PLANNING COMMISSION MEETING STAFF REPORT

NAME OF PROJECT: Watts Remund Farms Phases 4 & 5 PUD

AGENDA ITEM: Master Plan Amendment

Exhibit 3 - Proposed Master Plan

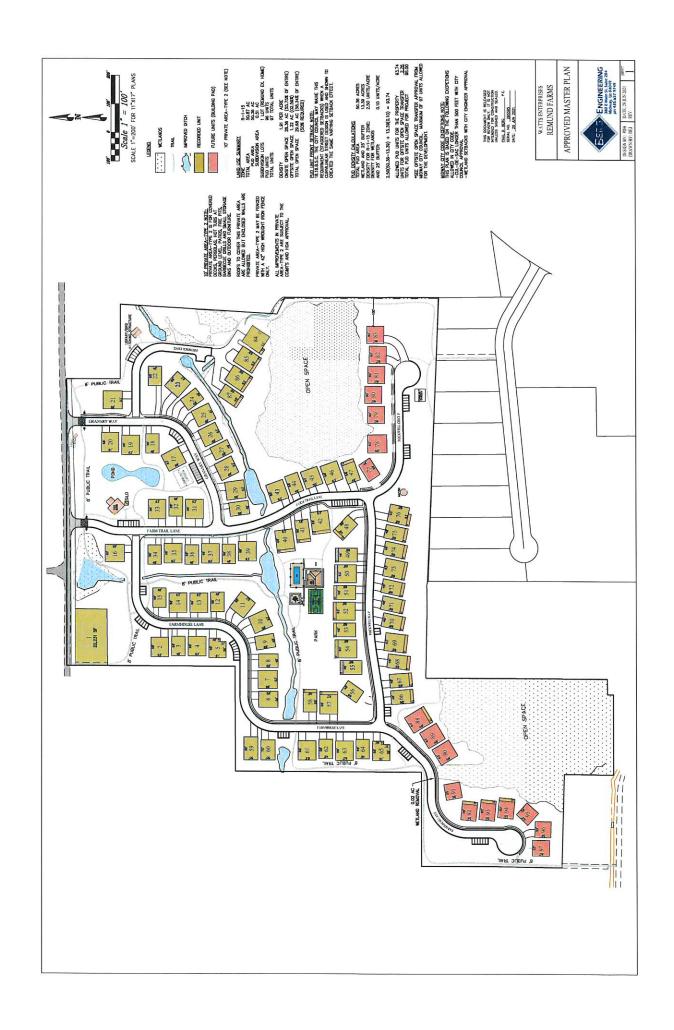
- The proposed master plan appears to meet the requirements of the code
- The building pads for twelve of the seventeen units will change in size creating an overall increase in building square footage and reduction in open space
- The setbacks from the proposed building pads to two of the peripheral boundaries in phase 5 will decrease. Setbacks in phase 4 will remain the same
- A public trail will be built as part of the subdivision that will benefit members of the community
- Amending the master plan is discretionary and the City is under no obligation to approve the proposal even if it complies with the land use code

- 1. The applicant will be required to pave an existing trail along Swiss Paradise Lane to be 6' in width. They will also be required to pave a 10' trail connecting the Swiss Paradise Lane trail, along the easement over Swiss Paradise lot 3 and into the sidewalk at the end of the cul-de-sac in phase 4 of Remund Farms.
- 2. The applicant will be required to contribute the funds associated with installing the 8' asphalt trail from Farm Hill Lane to 200 East to the general trails fund. The funds will be used when the trail is completed in the future as part of a larger improvement project.

Exhibit 4 – Proposed Open Space Plan

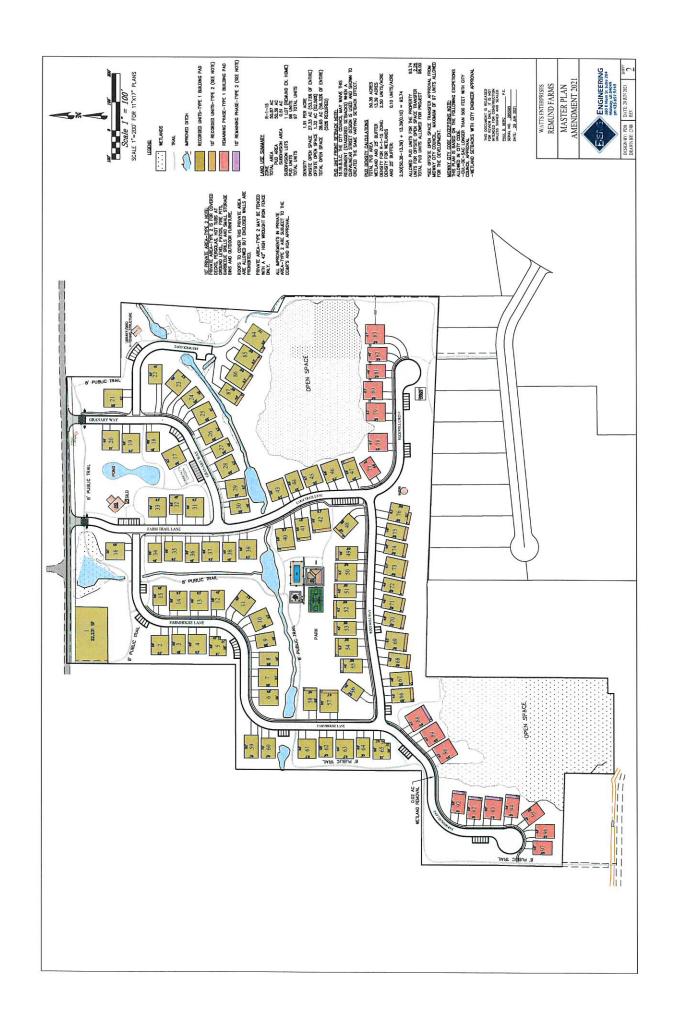
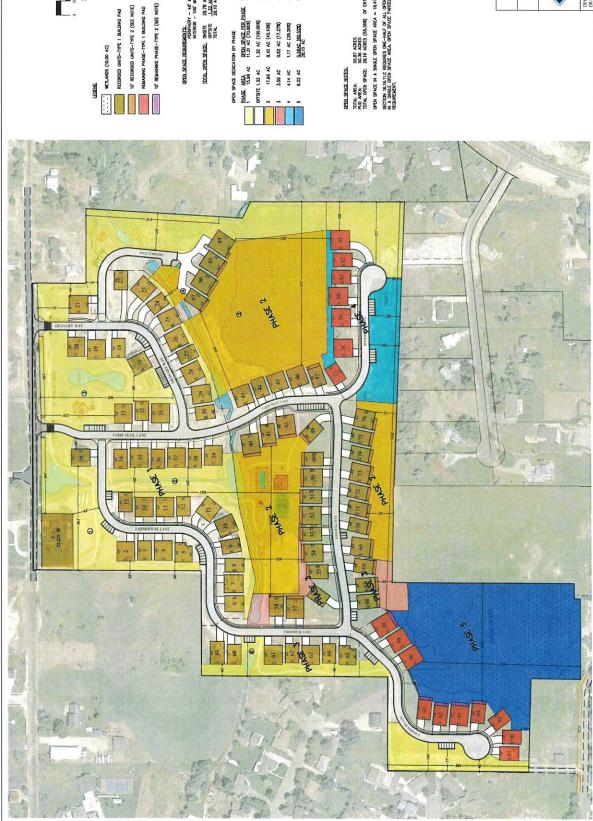
Open Space — The code requires that with each phase that is approved there is enough open space to comply with the requirements of the code. For example, phase I must have at least 50% open space for that particular phase. If phase I has 75% open space, then phase II only needs to have 25% open space if both phases are equal in acreage. Although the applicant is enlarging some footprints and decreasing others, the overall open space for the project decreases by 7,840 SF, or 0.18 acres due to the proposed adjustments. The proposed adjustments decrease the overall open space percentage from 55.51% to 55.24 %. The applicant has provided an amended open space plan and the proposed plan appears to comply with the 50% open space per phase requirement for the development.
